Appendix 2: Internal and External Consultee Representations

Stakeholder	Comment	Response
INTERNAL		
Arboricultural Officer	<p>I hold, from an arboricultural point of view, no initial objections to the hybrid planning application yet to be fixed (excluding Plot A).</p> <p>The 8.57 hectare site is within the North Tottenham Conservation Area.</p> <p>An Arboricultural Impact Assessment and Tree Survey has been carried out by Waterman Infrastructure Limited dated October 2021. The report has been carried out to the British Standard 5837: 2012 Trees in Relation to Design Demolition, and Construction- Recommendations.</p> <p>I mostly concur with the findings of the report and the quality assessment and the categorisation of the trees on site.</p> <p>There are 134 trees in total:</p> <ul style="list-style-type: none"> • Two category A • 61 category B • 66 category C <p>67 arboricultural features are proposed to be removed. Of these:</p> <ul style="list-style-type: none"> • 27 category B • 39 category C <p>It is proposed to plant 236 new trees. This is a 4:1 ratio for the loss of the above.</p> <p>A vast majority of these replacement trees will be suitable heavy standards to make an insta

Image 1: GLA Heat Risk Map for Tottenham Haringey (dark red is highest risk)

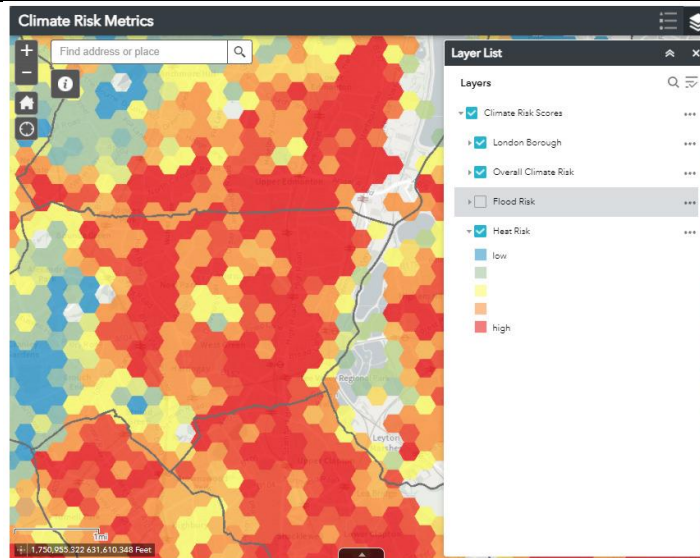
- As outlined during pre-application discussions, the model needs to be redone with London Weather Centre data (not Heathrow) to represent the urban heat island effect. Further justification was also included in the emails dated 29th October, demonstrating that Tottenham (and this area in particular) suffers from 'high heat risk', which is the highest level of risk, on the GLA Climate Risk Metrics map (screenshot added below – ref Image 1). In addition:
